TITLE: \${PROJECTNAME}

Revision By: E. Orosel

v12

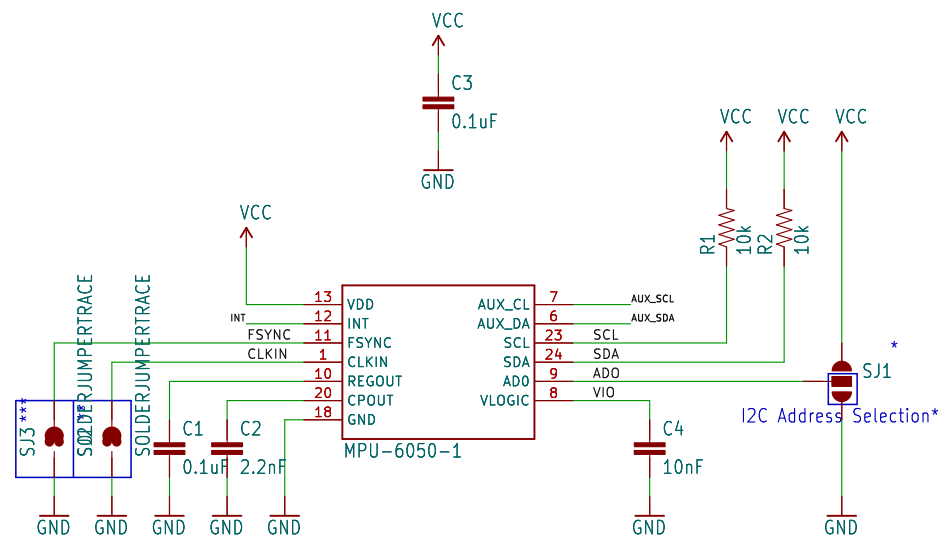
Changes to V11

SCL and SDA were switched on V10, fixed on V11
Broke out VLOGIC line
C2 was mislabeled as 10nF, should have been 2.2nF.
Added selectable jumpers to CLK, FSYNC and ADO
Minor layout changes
Played around with IC footprint.
Added 4 small tcream squares to middle pad.
Rounded and elongated pads.

BOM changes

YES
C2 is now 2.2nF instead of 10nF

Changes to V12:

-0402 --> 0603
-Changed Z-Axis symbol to reflect proper orientation from circle with x to circle with dot
-Changed NET labels in schematic to flags
